Tesla, Inc.
Service Bulletin

Rework Windshield Camera Fan

SB-24-10-006
June 26, 2024

Figure 1

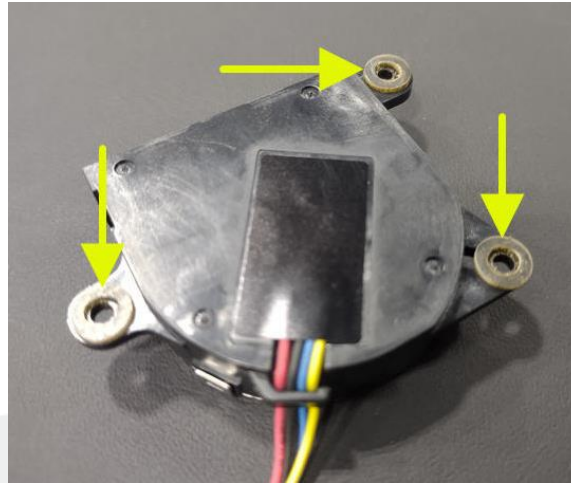
3. Position the adhesive side of the camera fan shims (x3) on the windshield camera fan (Figure 1).
